RE. Development of 3A Dawlish Drive, Ruislip HA4 9SF

Planning Ref. 14032/APP/2021/2749 Your Ref. ENF/753/22

Mr Leckie as the Enforcement Officer has noted 3 items on site which differs slightly from the deposited plans of the full application. Having looked at the 3 items, I wish to explain these small variances and the decisions behind them. With this information I would respectfully submit a Minor Variation Application to the original Approved Drawings.

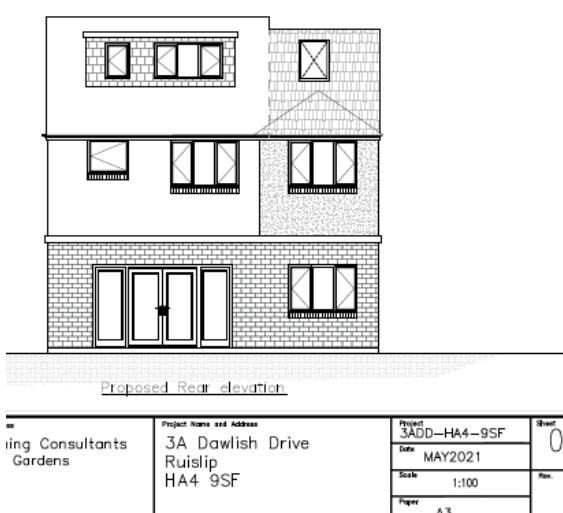
The reason of the small change is that the structural engineer placed the steel beam support for the floor, roof and dormer in a measured location and the contractor built off the beam resulting in the rear dormer wall being approx. 250mm closer to the rear of the building. This has enlarged the rear dormer wall downwards by approx. 200mm. and has not raised the dormer roof any higher than the Approved drawing, see detail photo below.

This photo shows dormer roof, existing roof ridge and new extension roof ridge. Also, the width of the dormer has not altered from the Approved Drawing, Revision shown on drawing 01 Rev A of the rear elevations.

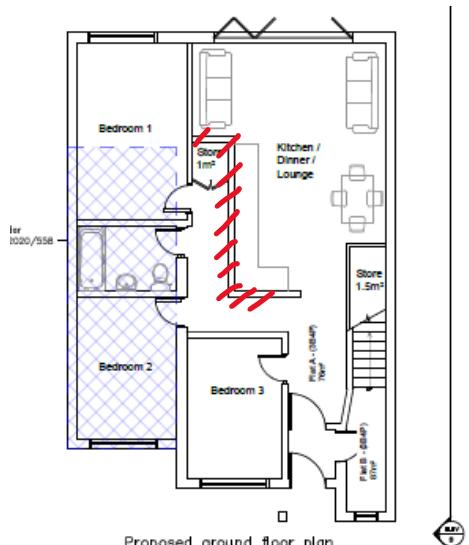
b) "Doors fitted to the kitchen at first floor level instead of a window as shown on drawing ... sheet 01."

The doors indicated by Mr Lockie have been installed as a larger opening window and resulted from a last-minute design decision to increase the size of the kitchen / dining area window in response to an agreed minor internal layout change with the Building Control Inspector.

The new doors are considered as an enlarged window, opening inwards for greater ventilation and amenity. The doors/window are not a full door size due to the insulated roof externally. The doors are strictly not for access onto the adjacent flat roof. The flat roof is not configured for use as a balcony. An iron "Juliet" balustrade will be placed across the external side of the doors to prevent casual access onto the roof.

Please review drawing 01 Rev A Rear elevation.

First Floor Plan

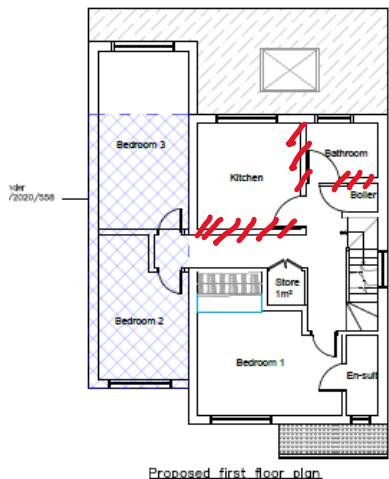
On discussion with the Building Inspector.
Omit internal walls to kitchen and bathroom.
Relocate bathroom to between the two bedrooms similar to the ground floor.
Kitchen to be relocate to where the bathroom is shown

Please review drawing 05 Rev A first floor plan
